knitter-switch

Product Change Notice P2021-9

Products affected: SMS 502, SMS 504, SMS 506, SMS 508, SMS 510
optionally followed by T, optionally followed by NF or G

appearance from production 2022 January

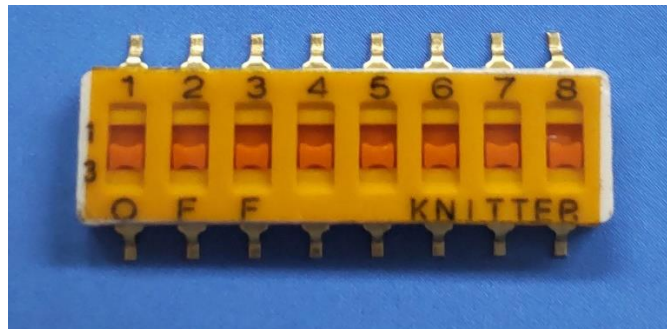
in order to avoid material procurement problems leading to unpredictable lead times the source of plastic material will change.

The new material color is ivory for base and cover (formerly black) and orange for the slider (formerly ivory).

The material class of old and new material is same (base, cover: PPS, slider: PA).

There is no change of dimensions, electrical and mechanical properties or other specification and packing.
